ADDENDUM NO. 1

MAY 21, 2025

100 BED NURSING HOME PRUITTHEALTH – GRANDE DUNES MYRTLE BEACH, SOUTH CAROLINA

L1

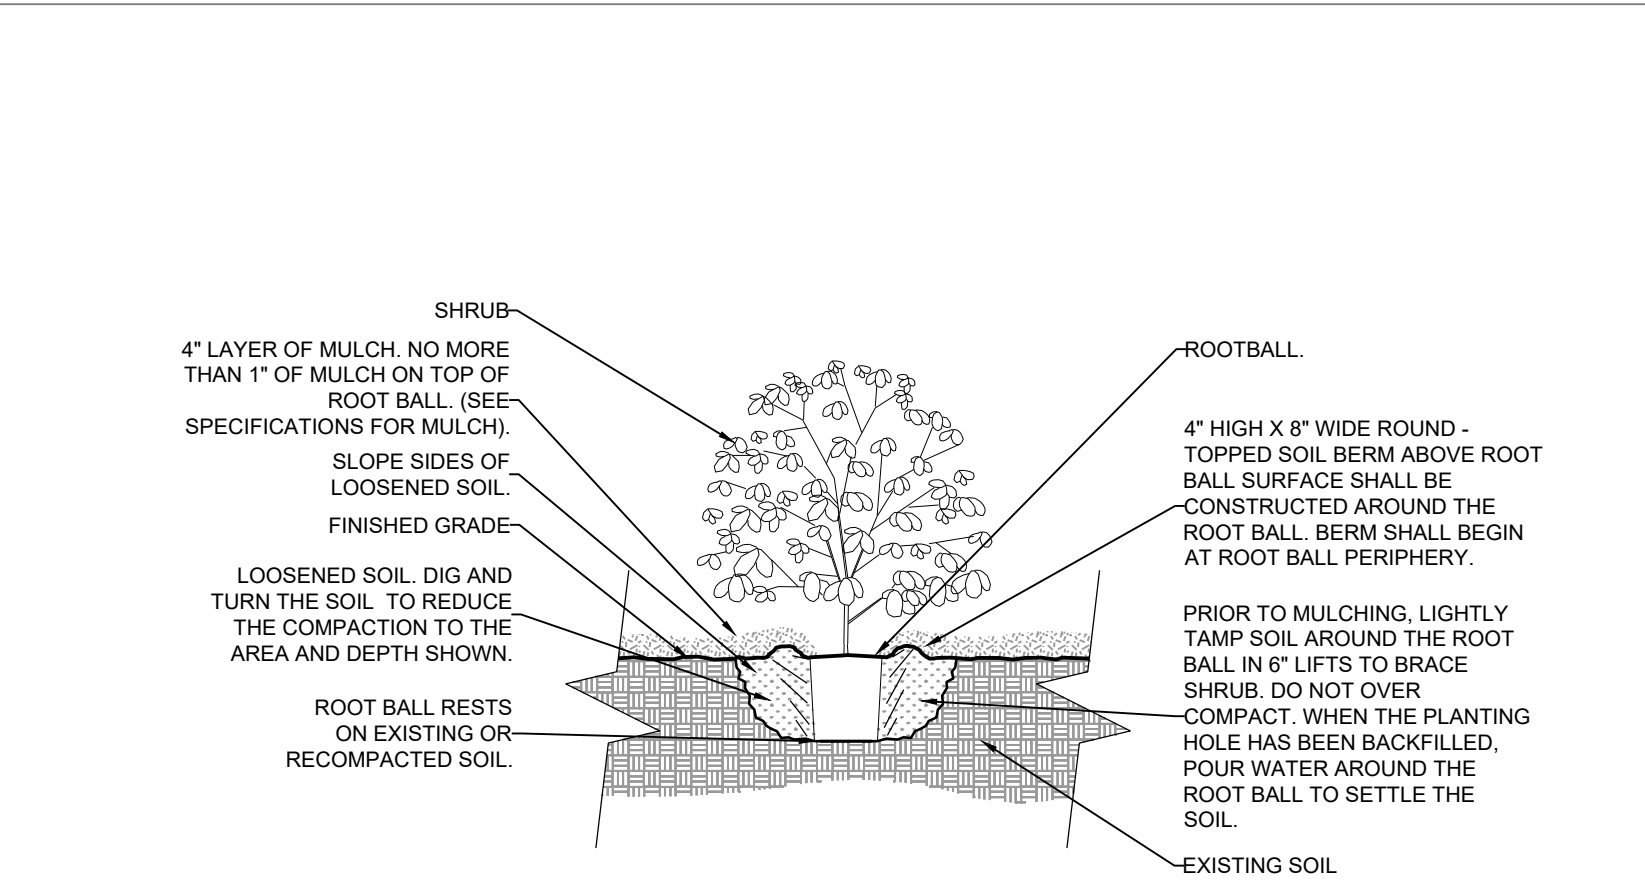
1. Attached landscape Sheets L1 and L2 to be added to the construction contract requirements. General Contractors to include in their base bid all landscape requirements detailed on attached Landscape Sheets L1 and L2.

FA
1.1

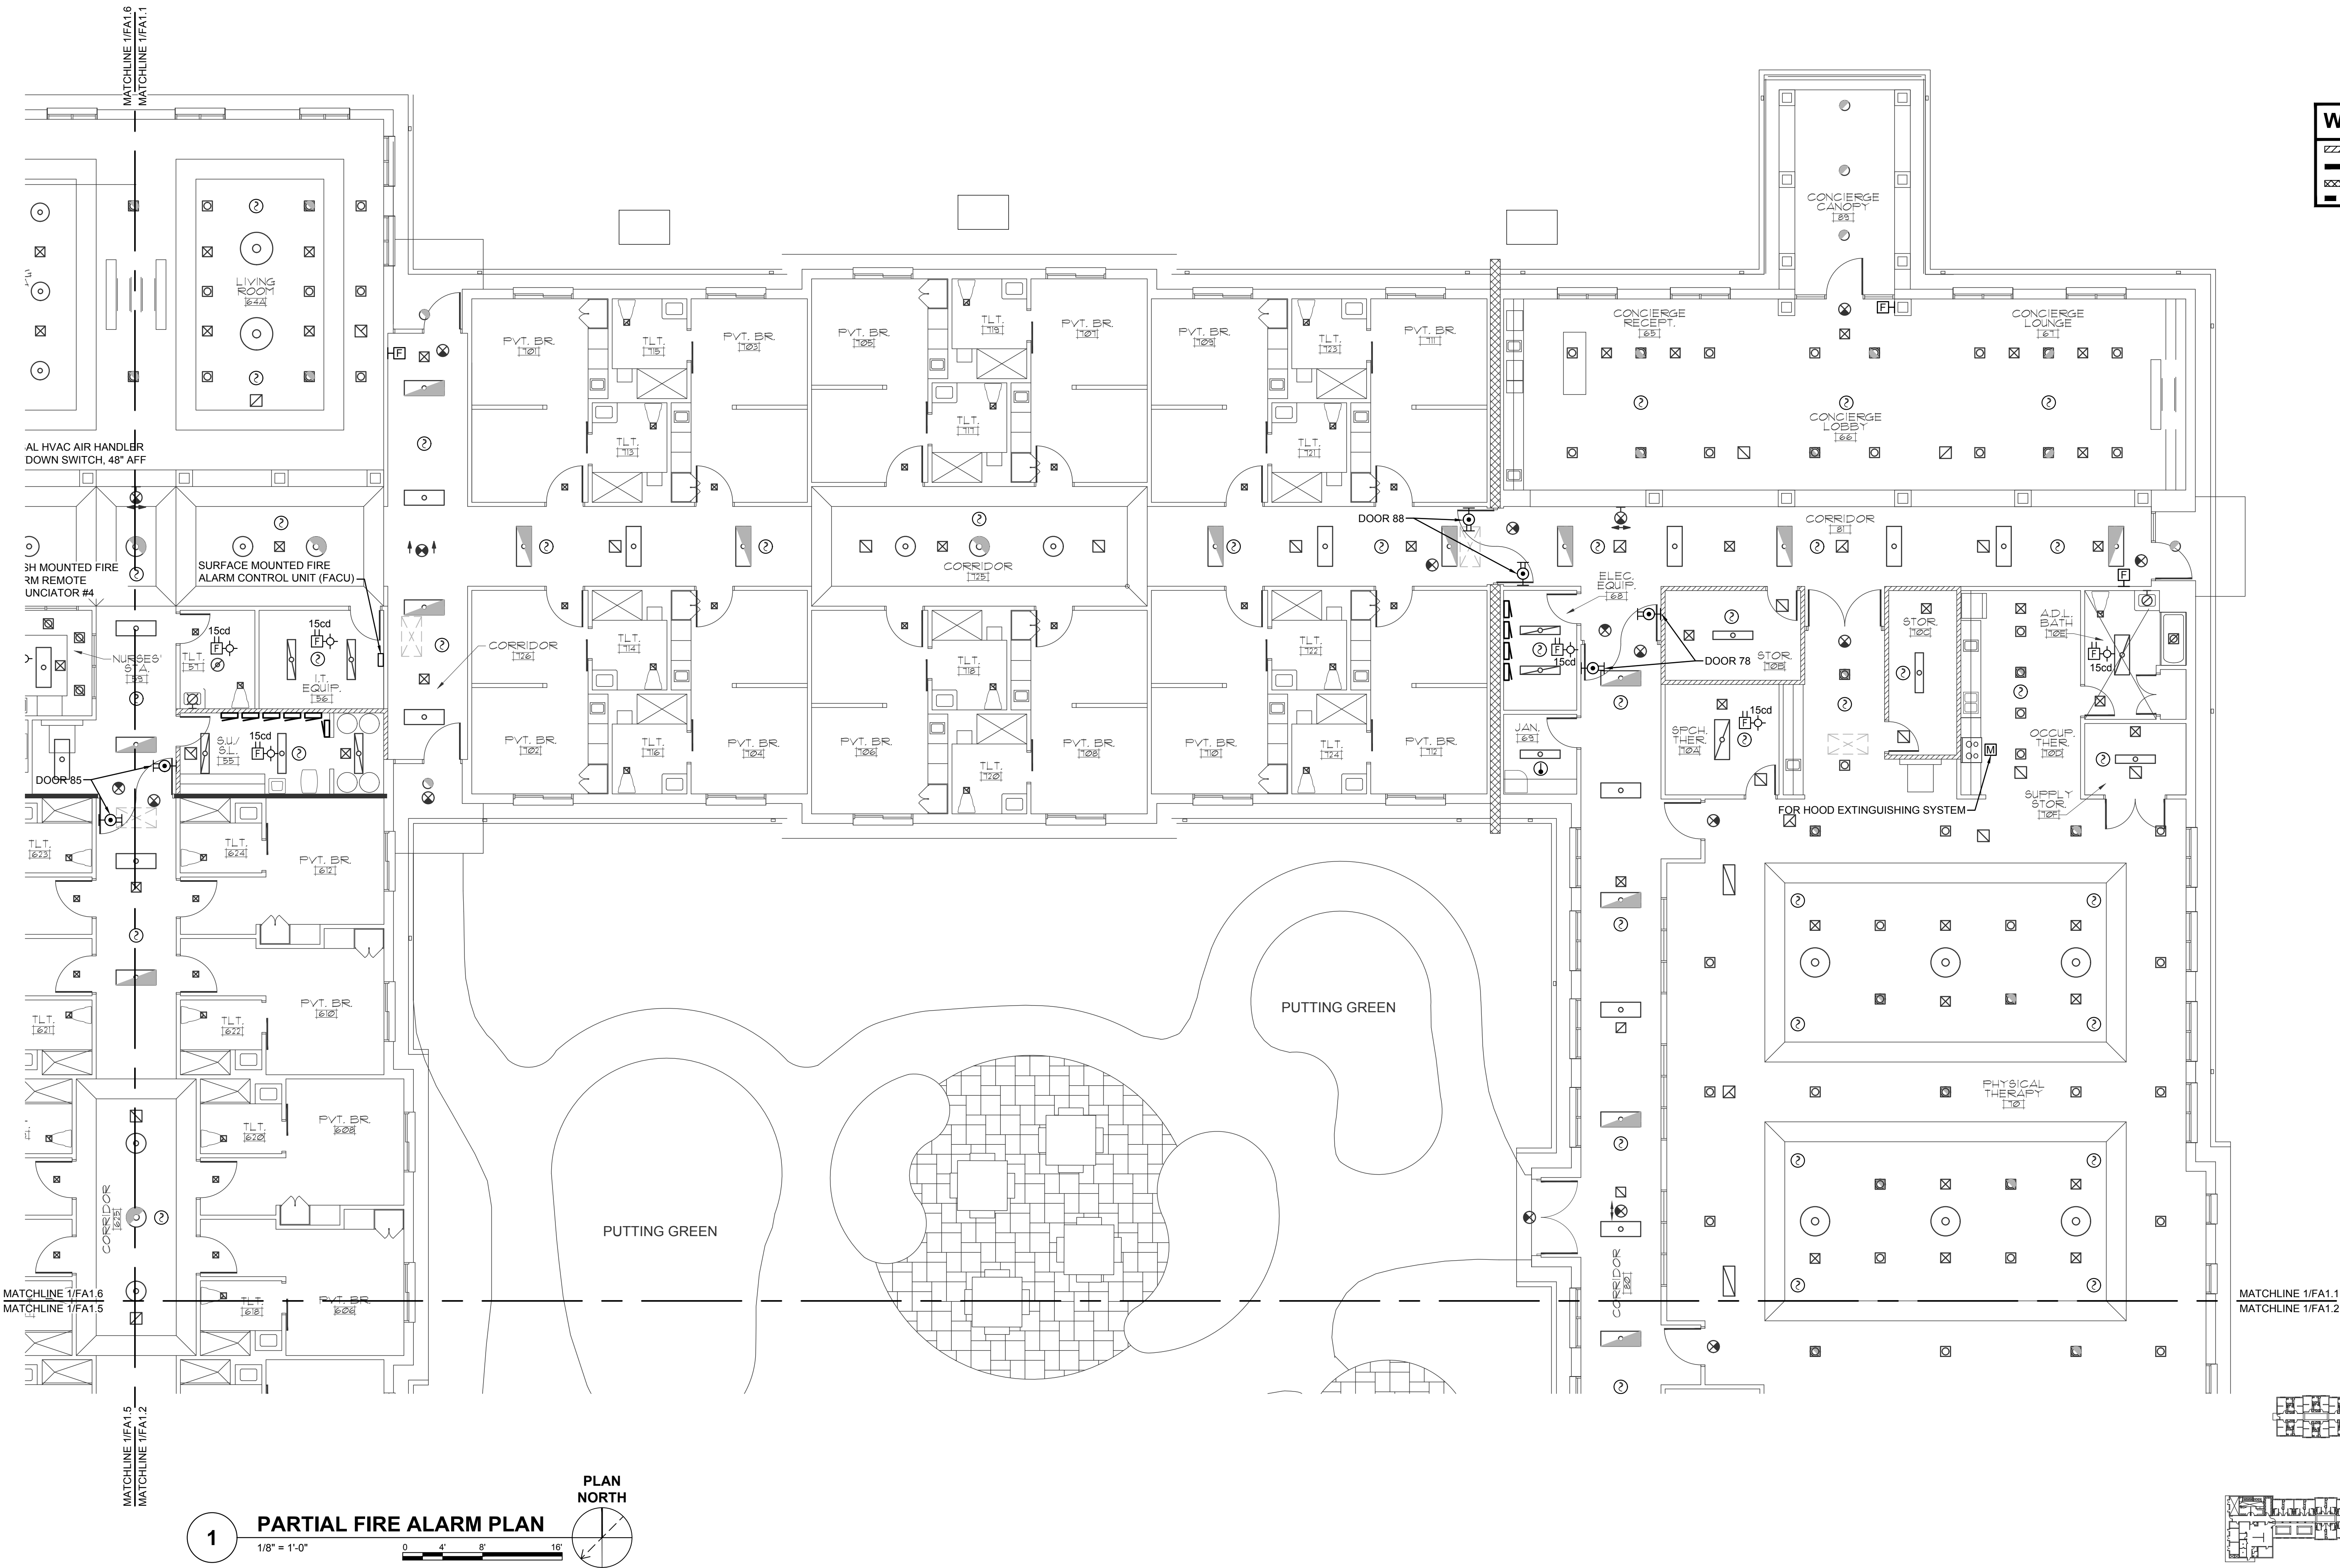
3. Sheet F0.1 adds new Occupational Therapy range hood fire suppression system to the Function Fire Alarm Riser and Fire Alarm system Control Matrix.
 4. Sheet FA1.1 adds the fire alarm connection to the Occupational Therapy range hood fire suppression system.

S1.10

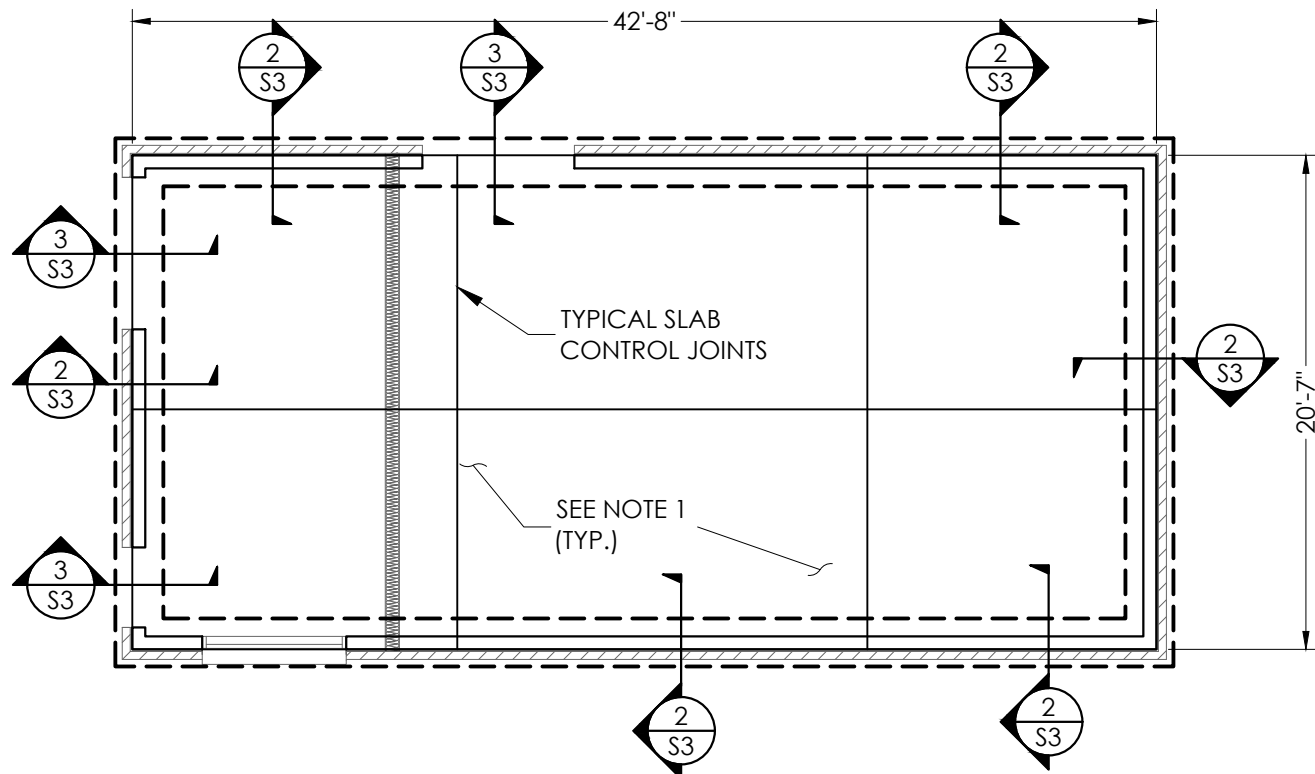
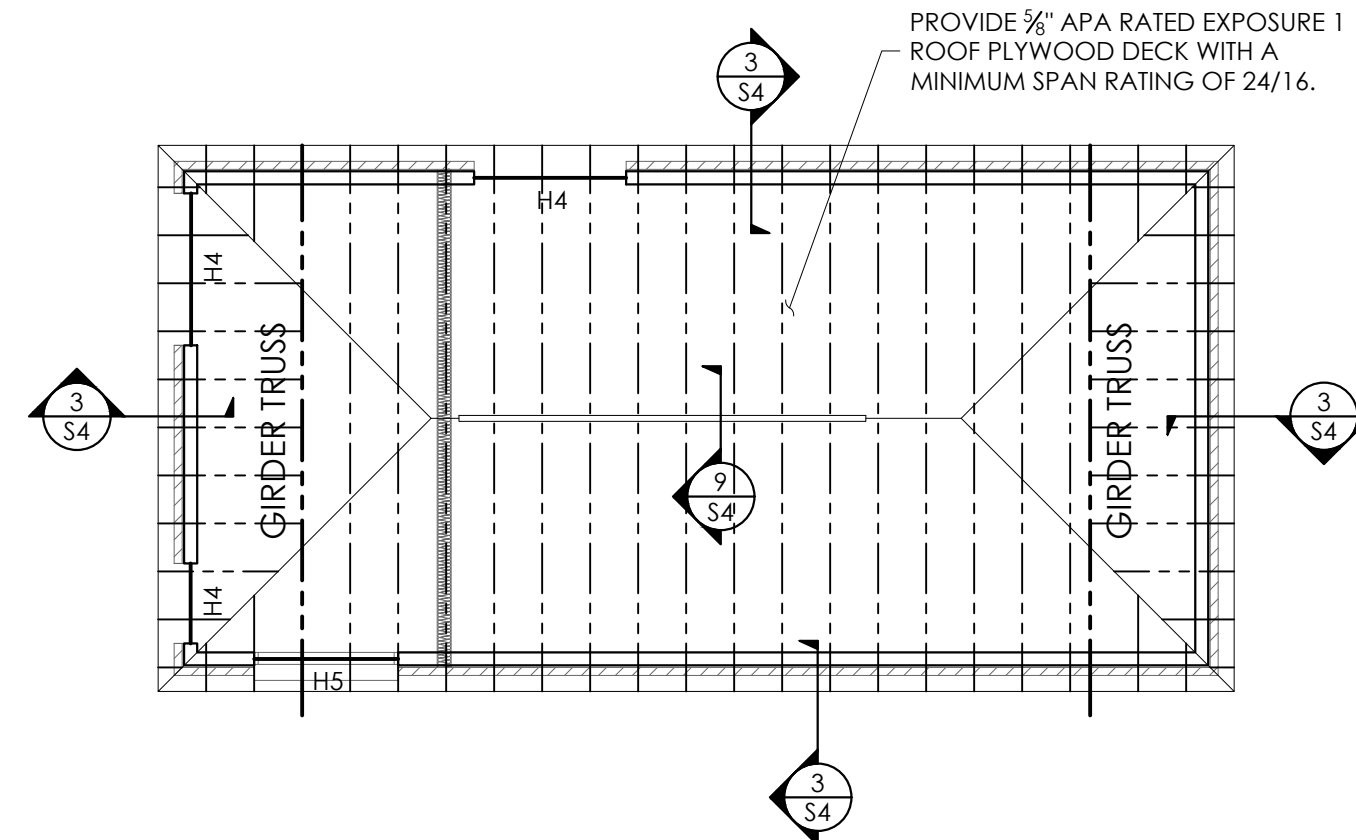
- C. STRUCTURAL:
1. Attached new Structural Sheet S1.10 to be added to the contract construction requirements. New sheet adds the Storage Building foundation plan, Storage Building framing plan and structural notes.
